DESIGNED: MAB	REVISION:
DRAWN: HIG	
CHECKED: MAB	
DATE: 11/26/18	
RESPEC 3520 AUSTIN BLUFFS PARKWAY SUITE 102 COLORADO SPRINGS, CO 80918 PHONE (719) 266-5212	
STAMP	
811 Know what's below. Call before you dig.	
PROJ NO. 03524 DWG NM. 03524-Dev-Fil2	
Guman & Associates, LLC 731 N Weber St, Suite 10 COLORADO SPRINGS, CO. 80903	
GLENEAGLE SUBDIVISION, FIL #2	
ROADWAY PLAN OVERALL	
DRAWING NUMBER: C	
SHEET 1

VR-18-018

GLENEAGLE
 SUBDIVISION,
 FIL #2

STONE EAGLE PL
 PLAN AND PROFILE

PEDESTRIAN INTERSECTION RAMP DETAIL
SCALE: 1" = 10'

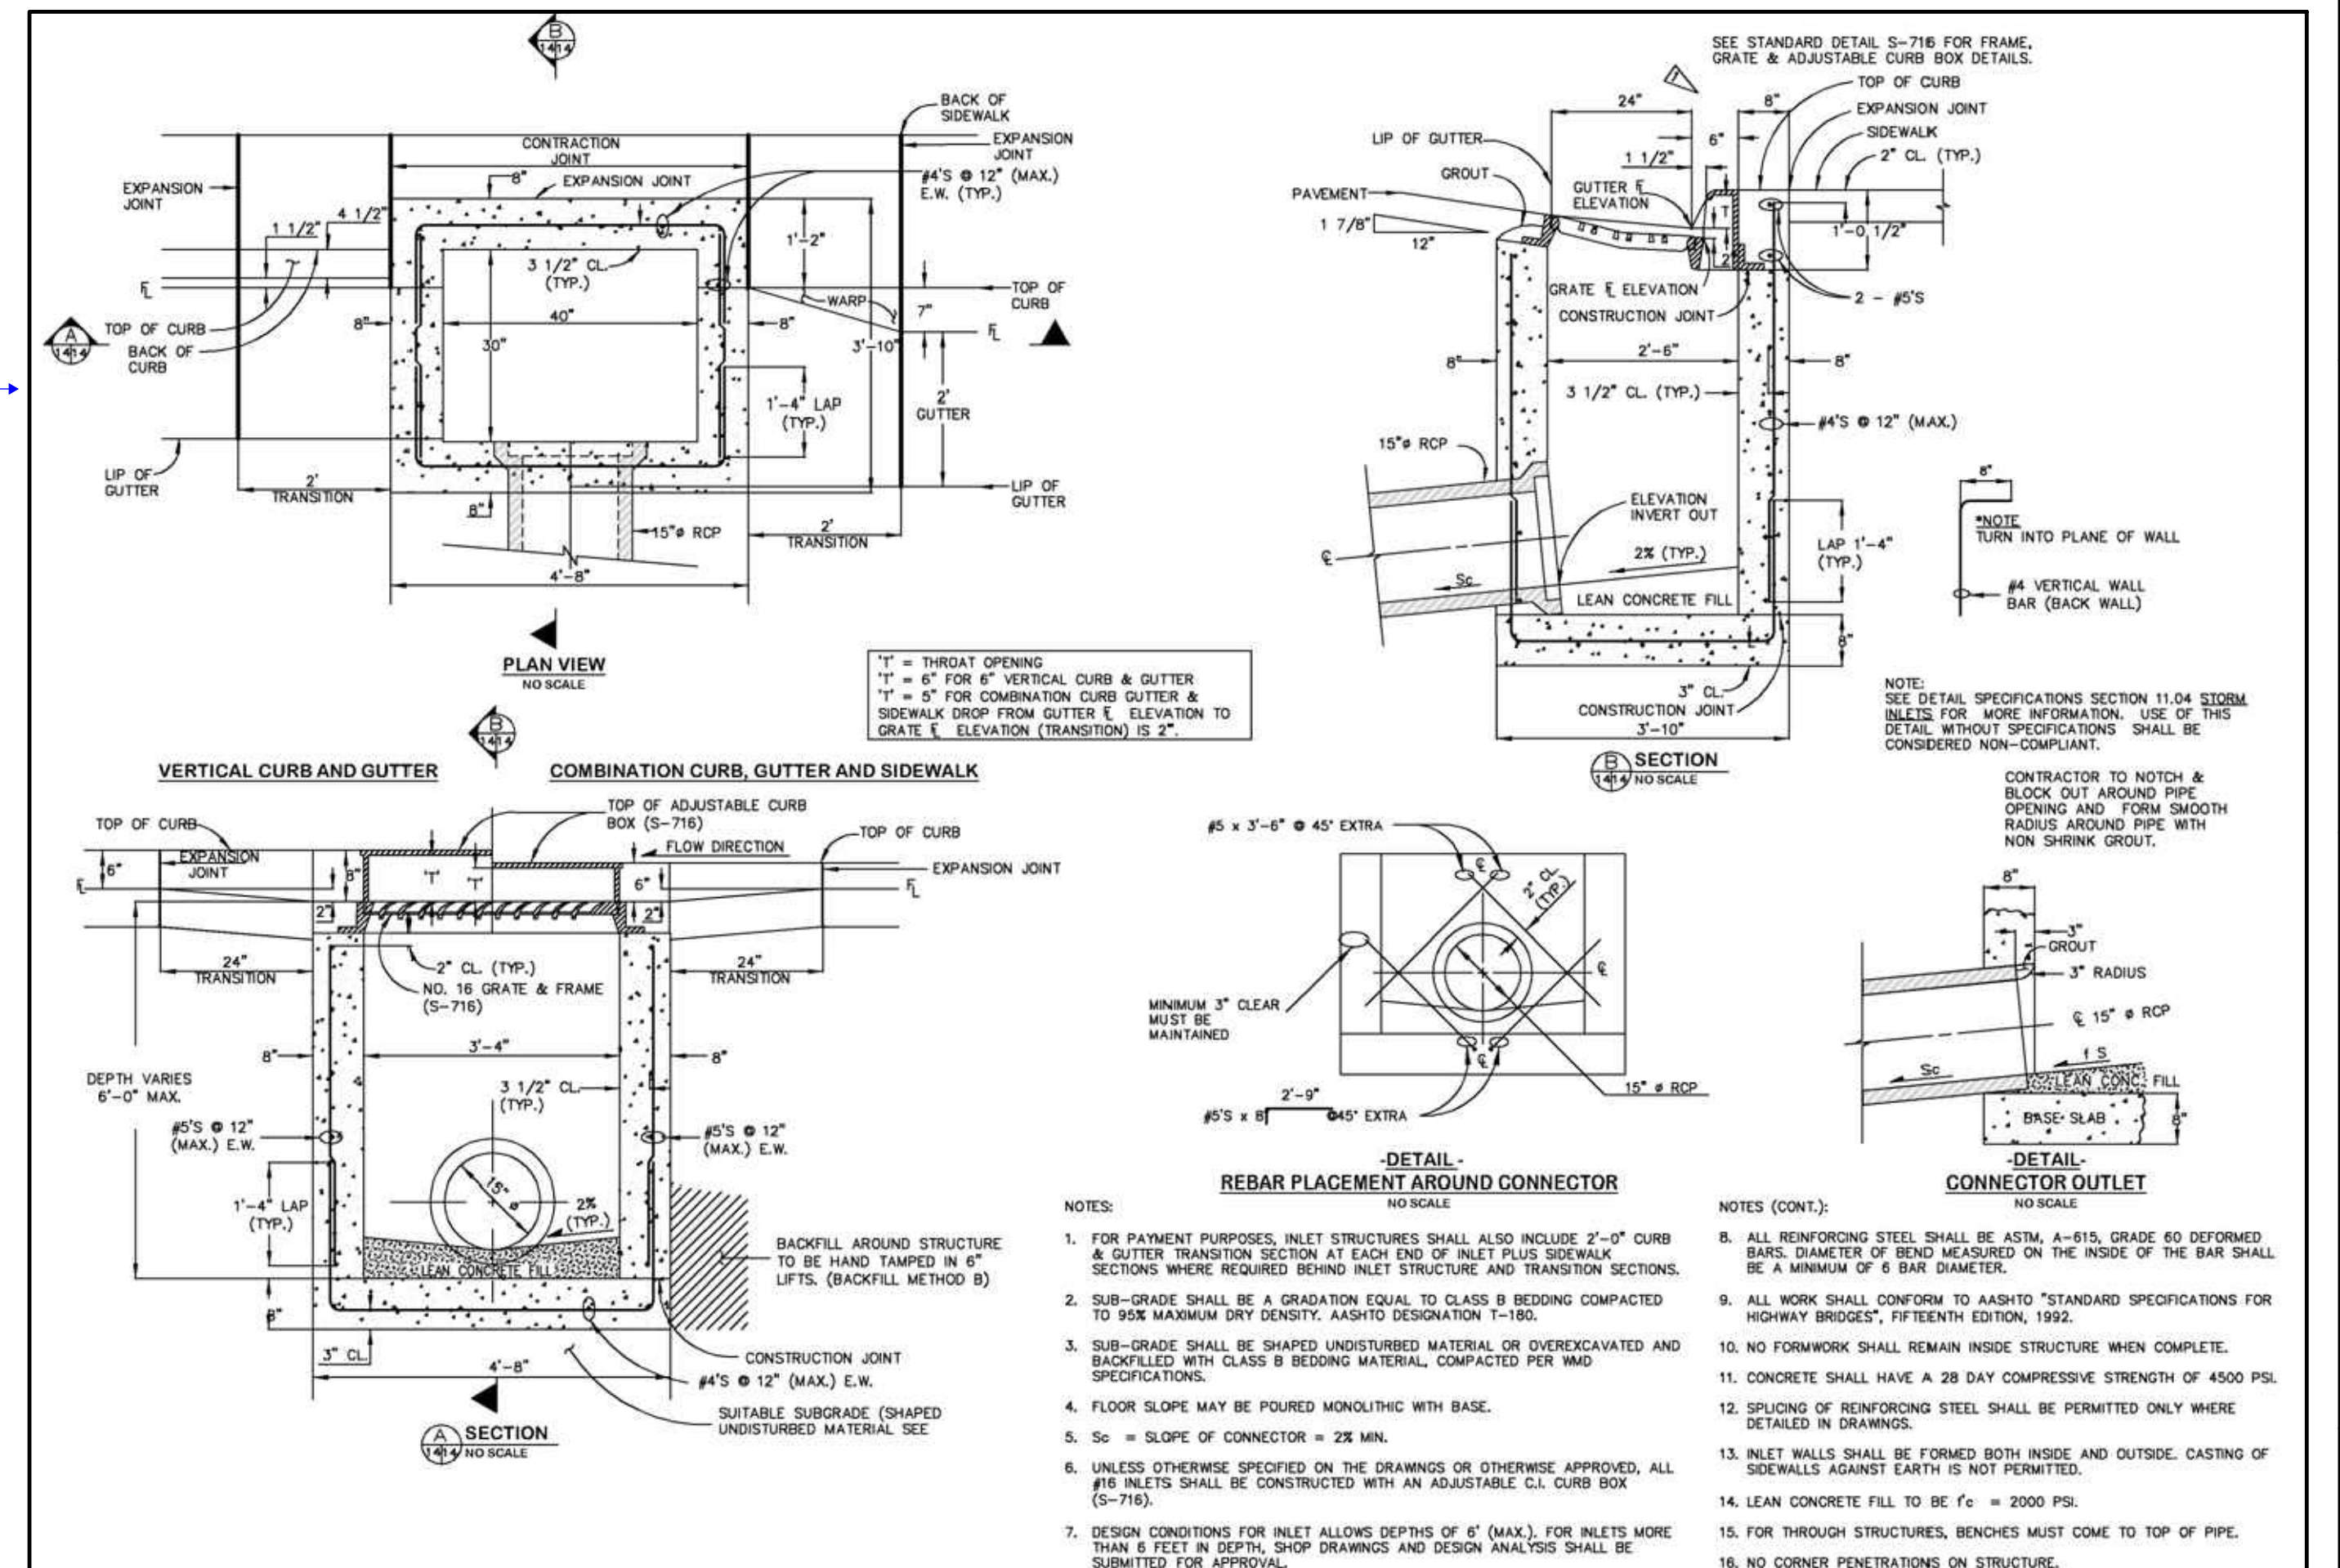
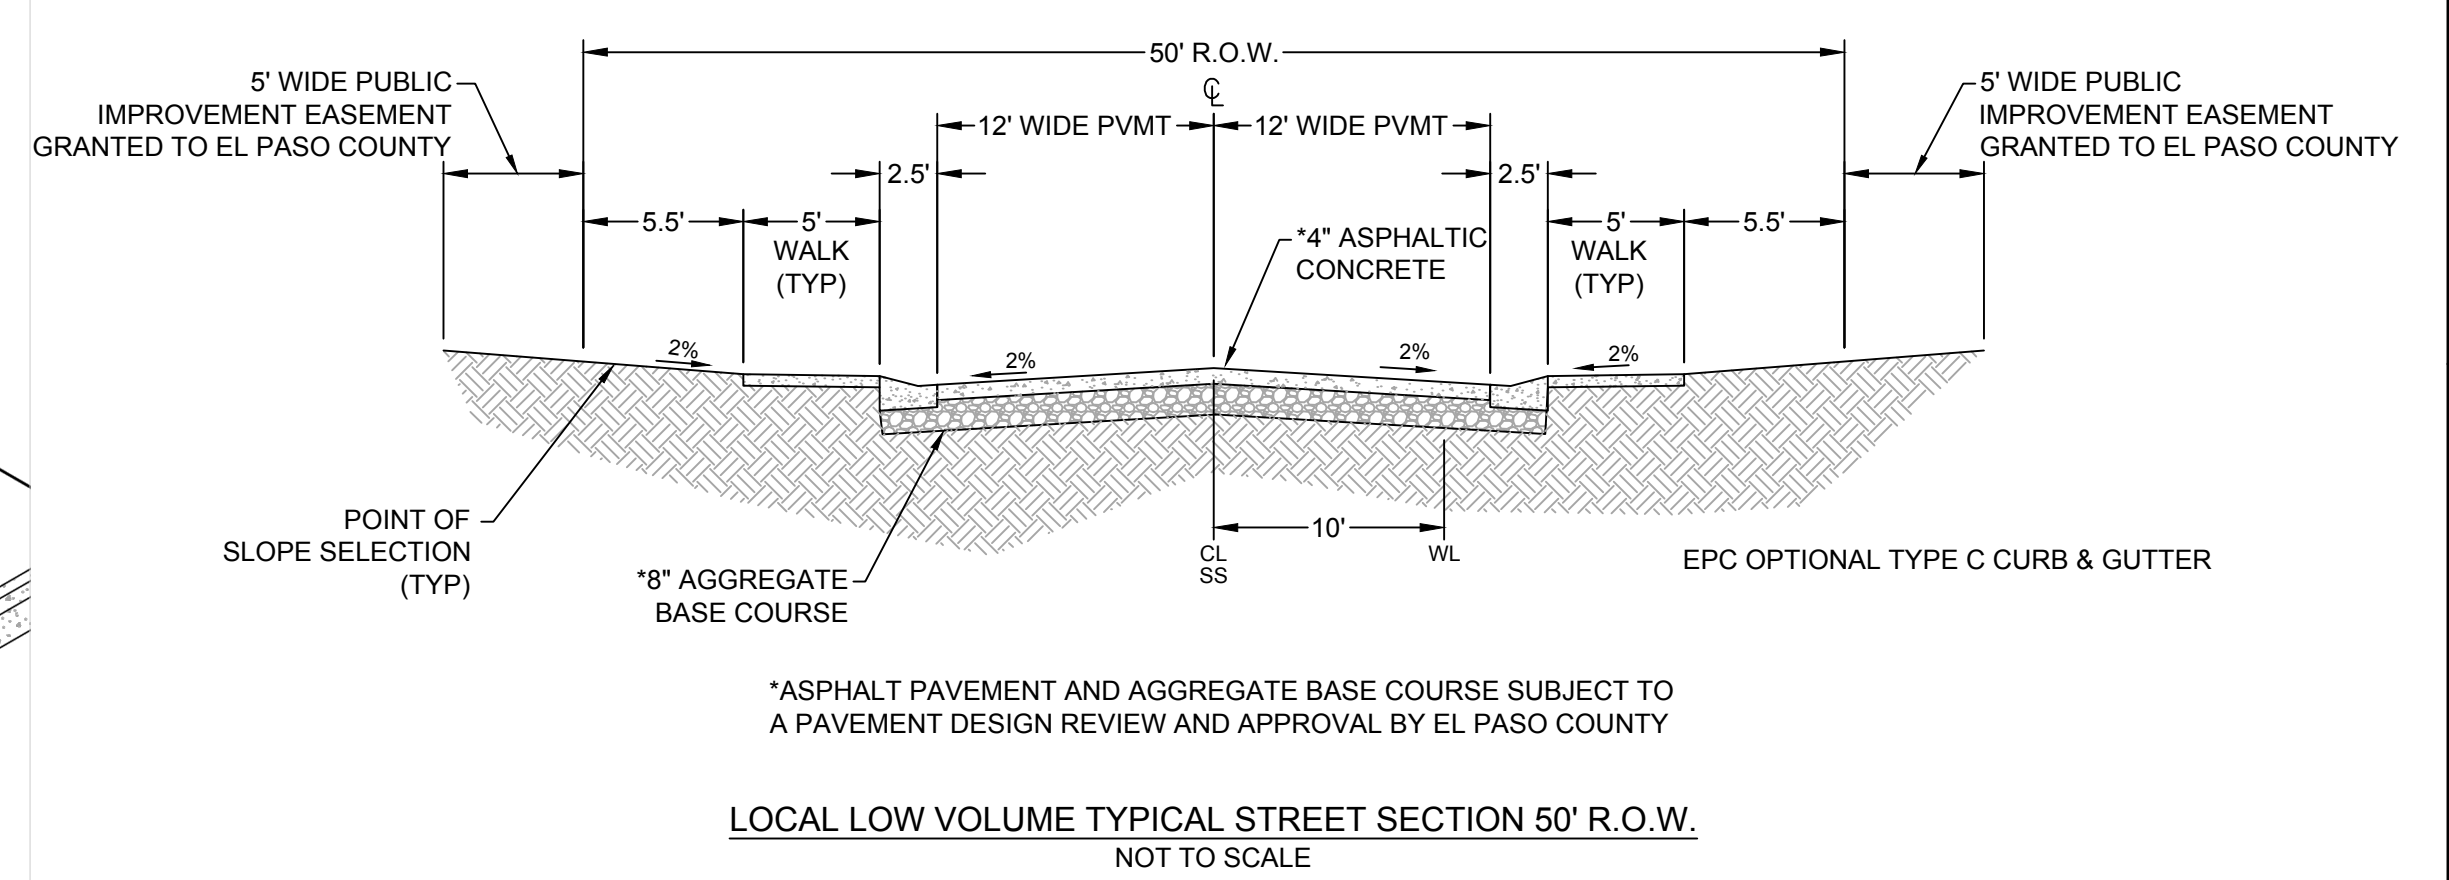
This detail should be a separate sheet to be legible when printed on 11 X 17
